**PROPOSED SOCIAL WELFARE FACILITY (RESIDENTIAL CARE HOME FOR THE ELDERLY) IN
“VILLAGE TYPE DEVELOPMENT” ZONE ON APPROVED NAM SANG WAI OUTLINE ZONING
PLAN NO. S/YL-NSW/10 AT LOTS 3670 RP (PART), 3671 RP (PART), 3672 RP (PART) AND 3673
RP (PART) IN D.D.104, NAM SANG WAI, YUEN LONG**

Town Planning Application No. A/YL-NSW/349 - Submission of Further Information (3)

Response-to-Comment Table

FIGURE 3
PROPOSED TERMINAL MANHOLE AND
CONNECTION

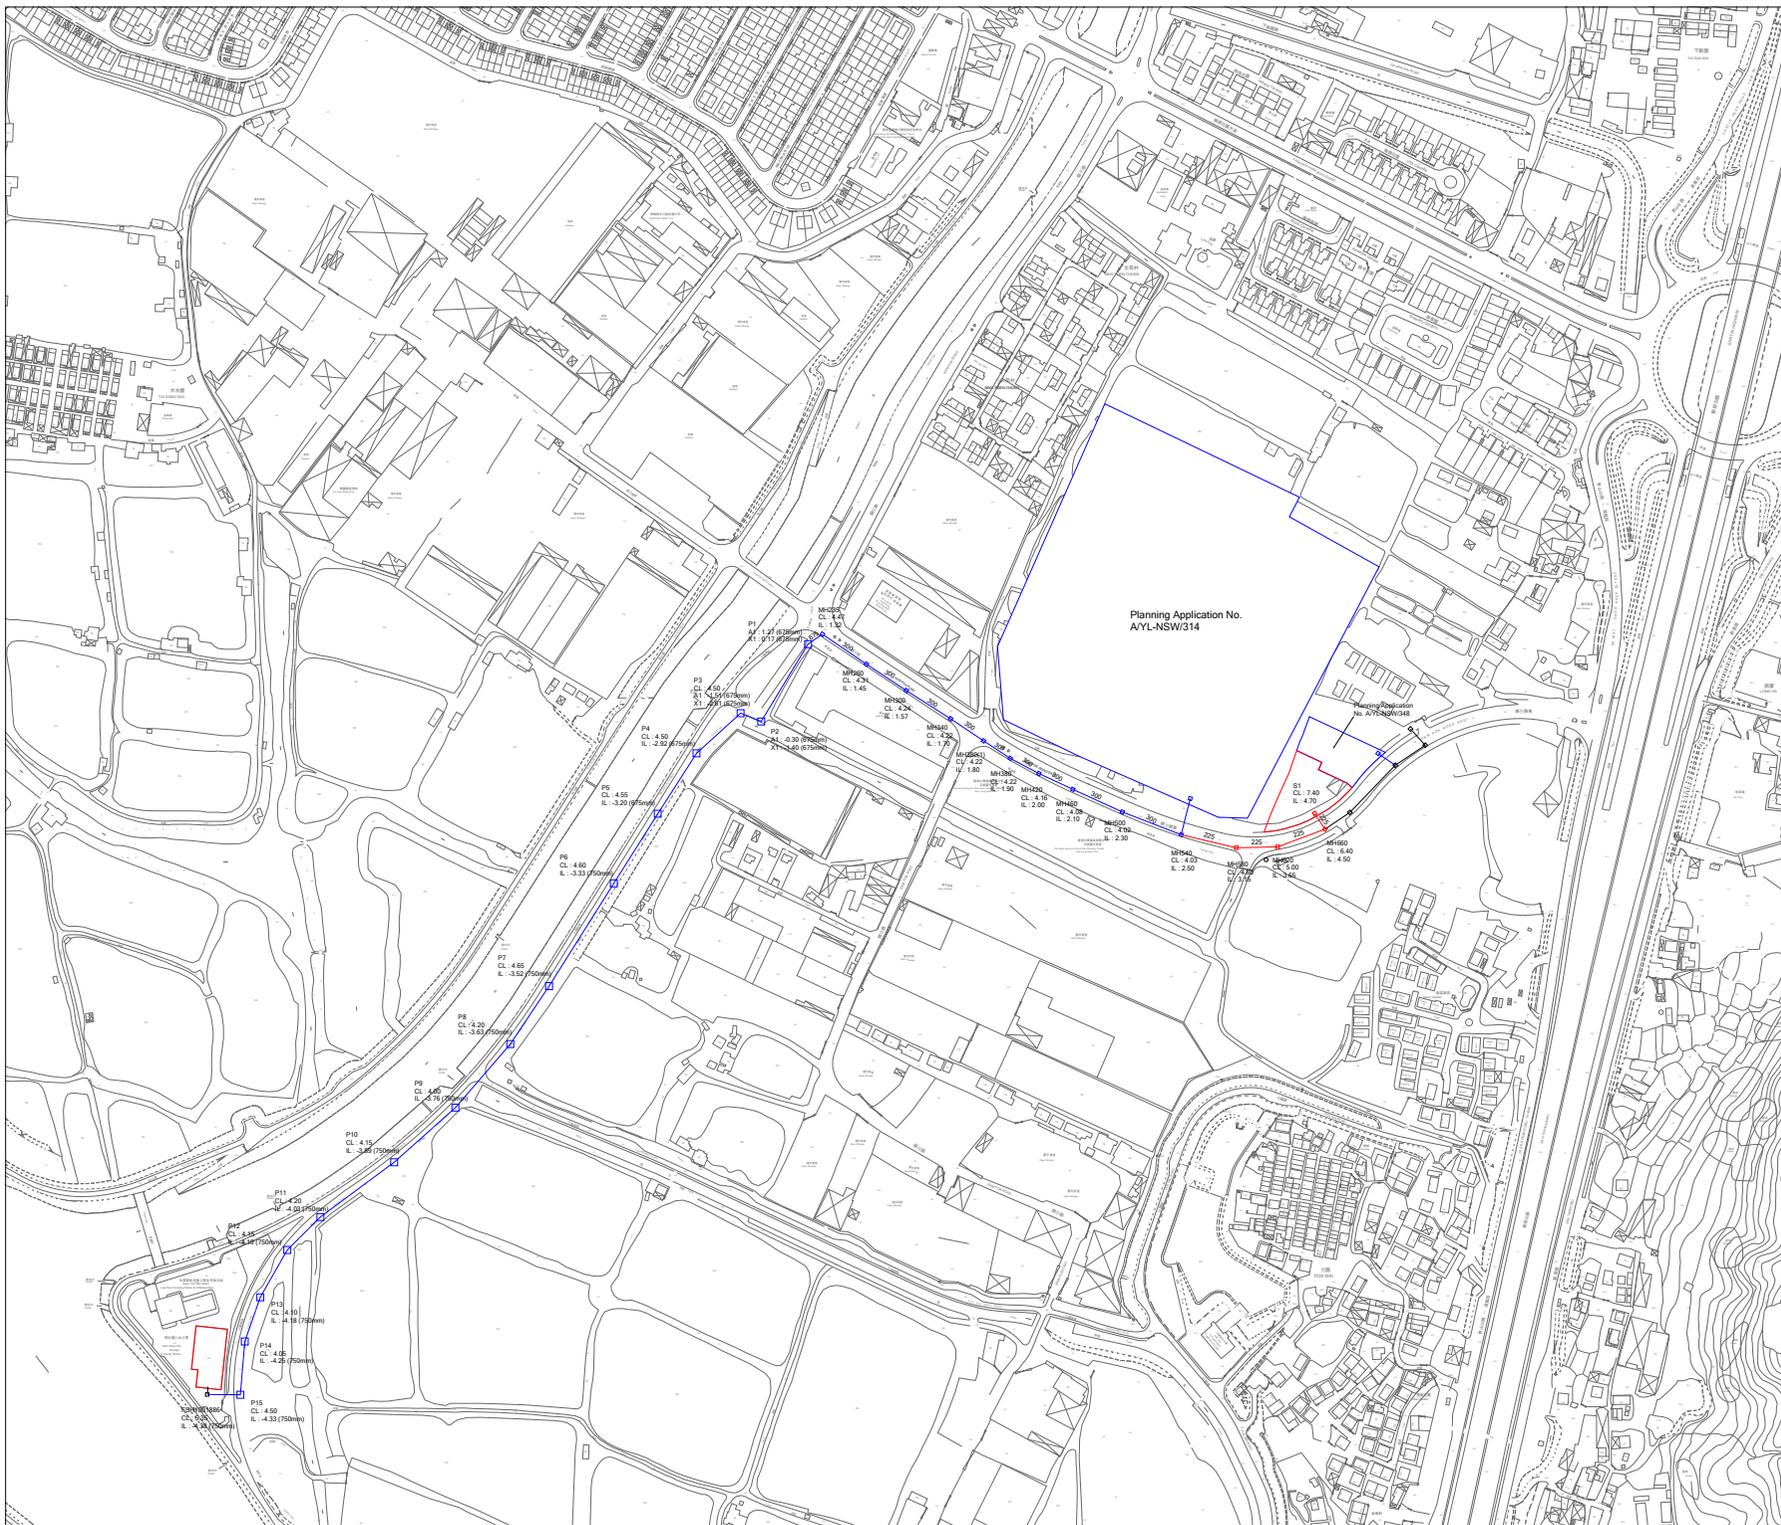
| 2. Figure 3: Information of existing sewerage system shown on the submitted sewerage plan is different from our sewerage record. The applicant should clarify discrepancies and advise whether modification of existing sewerage system is required and would be implemented by the applicant for the proposed development. Also, the applicant should clarify management and maintenance responsibilities of the proposed sewerage system after modification work (if any). | More information of existing sewerage system and proposed sewerage system including management and maintenance responsibilities are provided in Section 2.2 to 2.5. |
| 3. Section 3.1.2 & Figure 3: The applicant should clarify whether 300 mm dia. sewers are existing sewers or newly proposed sewers. Also, the applicant should clarify words, i.e. '...existing sewerage system...' | 300 mm dia. sewers are proposed by approved planning application A/YL-NSW/314. |
| 4. Figure 3: For Catchment A, the applicant should provide information regarding the proposed development at private lots (Lot No.: 3670 RP, 3671 RP, 3672 RP and 3673 RP in D.D. I 04). The applicant should also clarify whether Catchment B is referring to another planning application (No.: ANL-NSW/314). Besides, please clarify the mitigation measures if the sewerage works proposed under other planning applications, such as A/YL-NSW/314, Y/YL-MP/10 and etc., could not match with the programme of the proposed development. | Figure 3 is revised accordingly. For situation if the sewerage works proposed under other planning applications, such as A/YL-NSW/314, Y/YL-MP/10 and etc., could not match with the programme, there will be no population intake for the proposed development until proposed sewerage system becomes available. Relevant explanation is provided in Section 2.4. |
| 5. Figure 3: Please clarify the '-' sign of cover levels and invert levels shown on the submitted drawing. | '-' sign refer to height below m.P.D. level. |
| 6. Figure 3: The applicant should clarify invert levels of the proposed foul water manhole P3. Invert levels of the proposed sewerage facilities at the upstream shall be higher than that at the downstream. | The invert level is revised. |

| <p>7. Figure 3: The ID nos of the existing government manholes to which sewerage connection is made should be indicated on the submitted sewerage plan.</p> | <p>Noted.</p> |
| <p>8. Figure 3: The applicant should clarify cover levels of the proposed manholes PI-P15. Also, the applicant should clarify whether manhole E1 shown on the submitted sewerage plan is existing foul water manhole FSH1001886. The applicant should indicate cover level and invert levels of existing foul water manhole FSI-11001886 on the submitted sewerage plan for reference.</p> | <p>Cover levels are provided. Manhole E1 is revised to manhole FSH1001886.</p> |
| <p>9. Figure 3 & Appendix B: The applicant should clarify discrepancy of size of sewer connecting the proposed manholes MH235 and PI. Also, the applicant should clarify invert level of the proposed sewer connecting to manhole E1.</p> | <p>Size of sewer and invert level is revised and corrected.</p> |
| <p>12. Figure 3: The applicant should note that there are several planning applications/proposed developments in the vicinity of the application site and the sewerage system proposed under the subject planning application may have conflict with that proposed under other planning applications (No.: Y/YL-NSW/7 and etc.). The applicant should liaise and coordinate with EPD and other project proponents to confirm the proposed sewerage design and ascertain responsibilities of implementation and maintenance of the proposed sewerage works.</p> | <p>Noted, further liaison with EPD/DSD and the other future developments near the Proposed Site would be in later stage.</p> |

Figure Title **G/F LAYOUT PLAN**

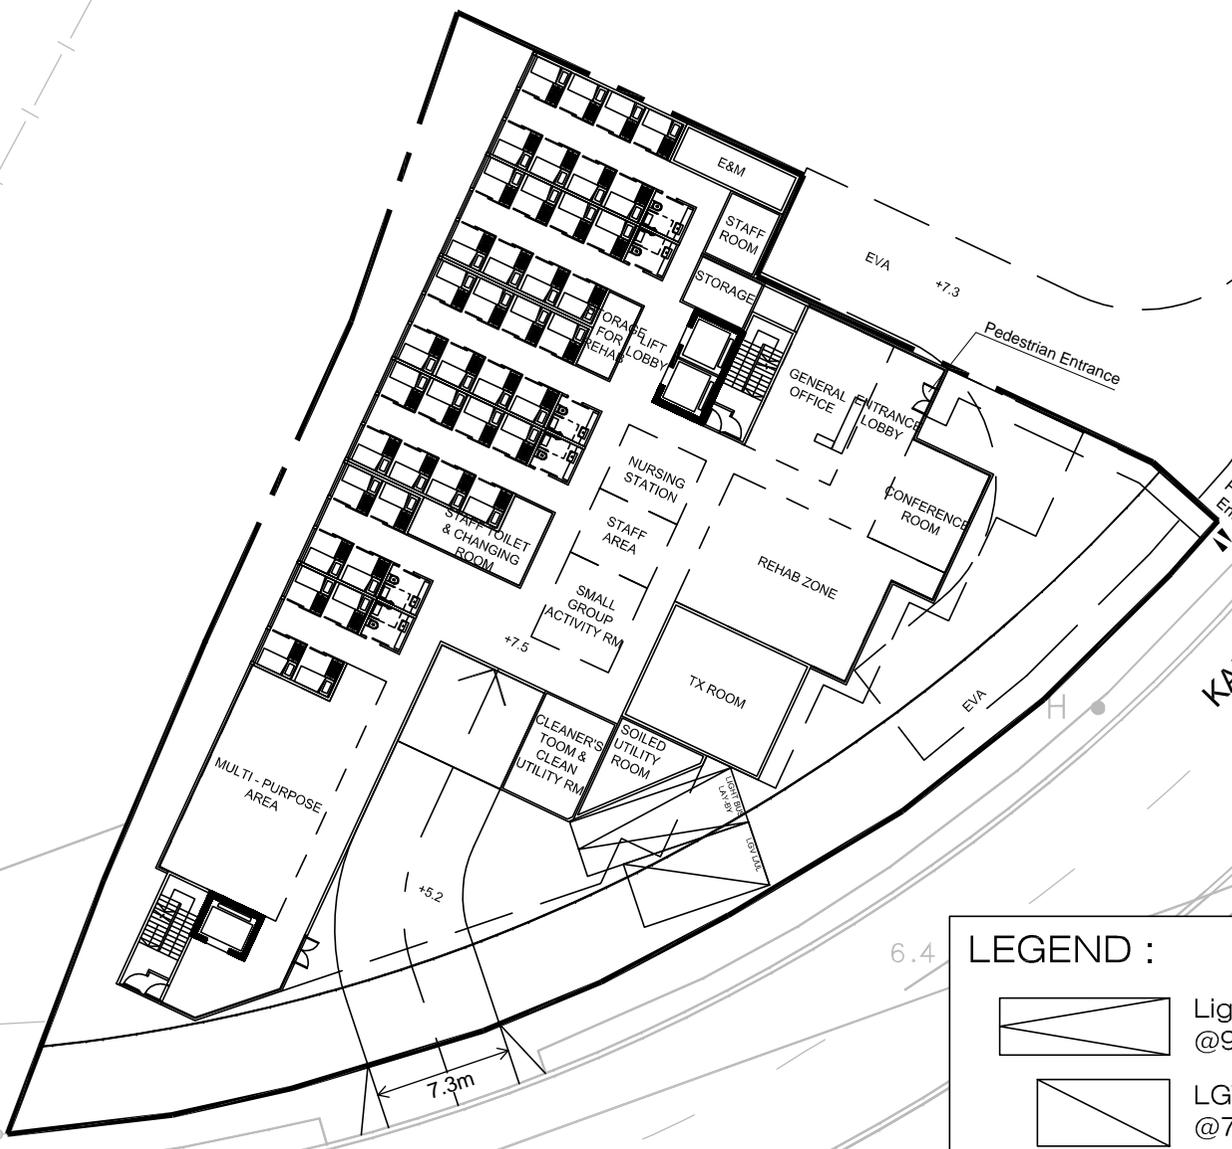
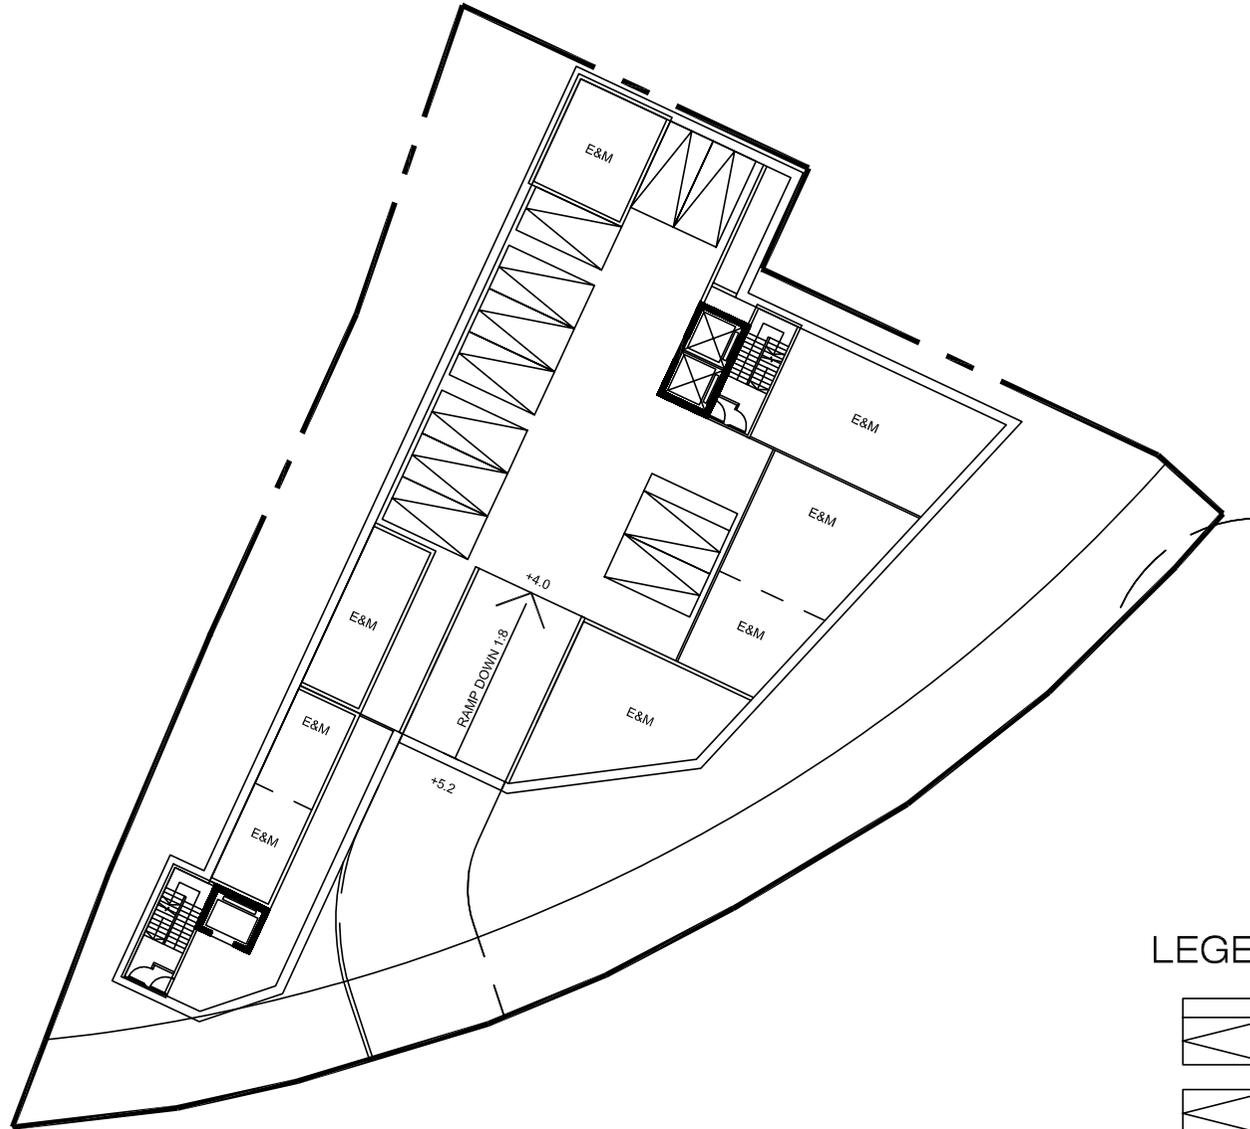
| 5. | In the site entrance, please provide a clear segregation between vehicles and pedestrians from road safety perspective. For the proposed pedestrian entrance in the building in Figure 3.1, apparently pedestrian is expected to walk across the vehicle manoeuvring area (i.e. light/ambulance, LGV, PCs/taxis) which poses a safety concern. Please review. | Pedestrian entrance provided for the Proposed RCHE is separated from the manoeuvring area. Please refer to the Figure 3.1 in the revised TIA report. |

T:\JOB\J7400-J7449\J7401\2025 10\Fig 3.3 RevC.dwg

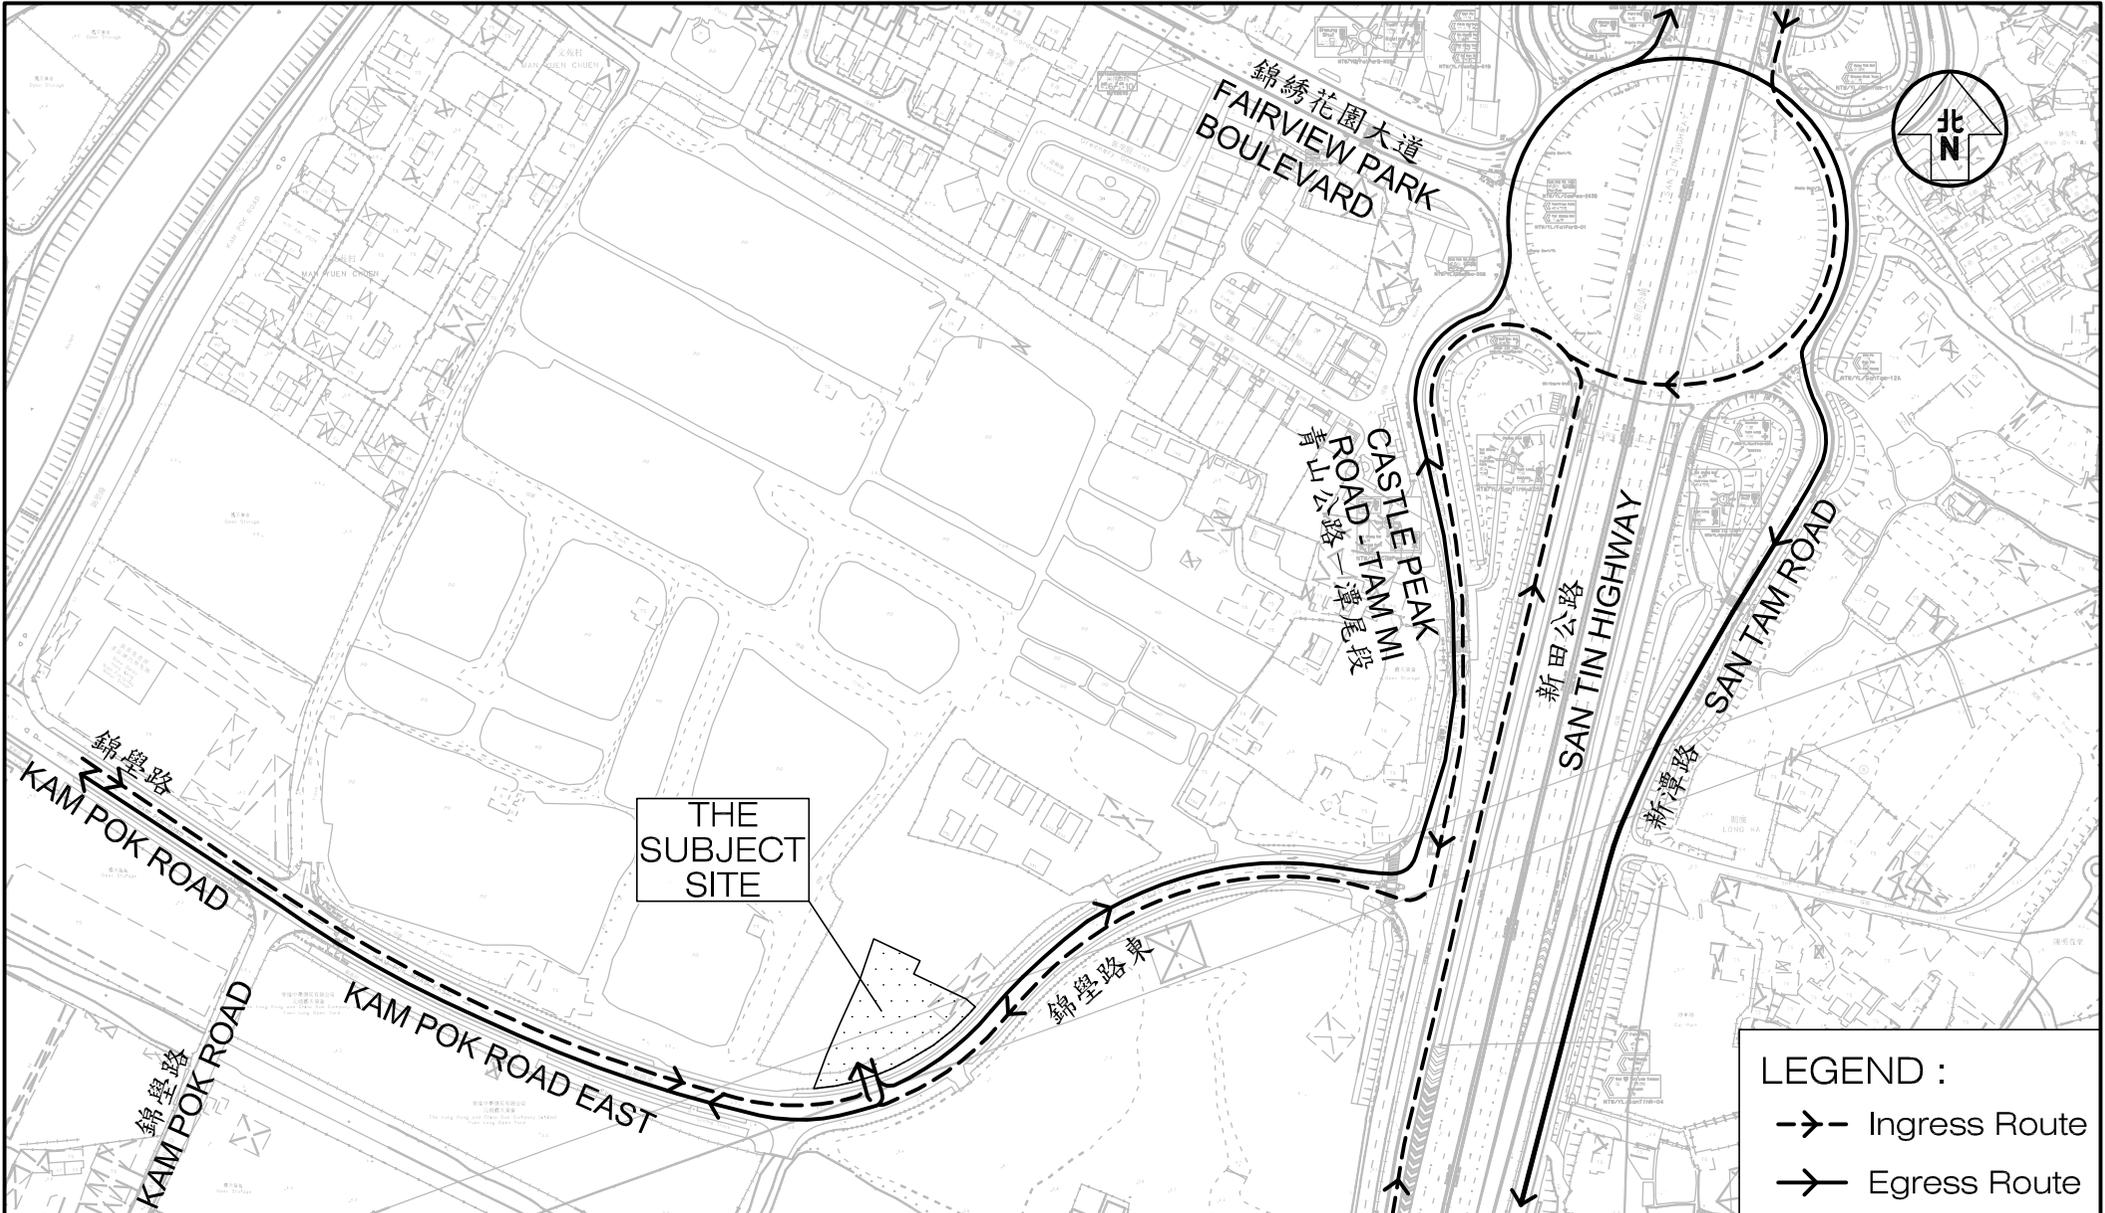
| 6. | Figure 3.3: Unless otherwise agreed by the relevant departments including but not limited to EPD and HyD that the existing noise barrier can be demolished, please demonstrate adequate sight line can be provided at the ingress/egress with the presence of existing noise barrier. | The noise barriers have been indicated in the Figure 3.3 in the revised TIA. The measured length of visibility splay for the motorists leaving the Proposed RCHE is 60m to the left and 60m to the right, so adequate sight line can be provided at the ingress/egress. The detailed design for necessary alterations of affected noise barrier and planters will be further dealt with at the land exchange stage. |
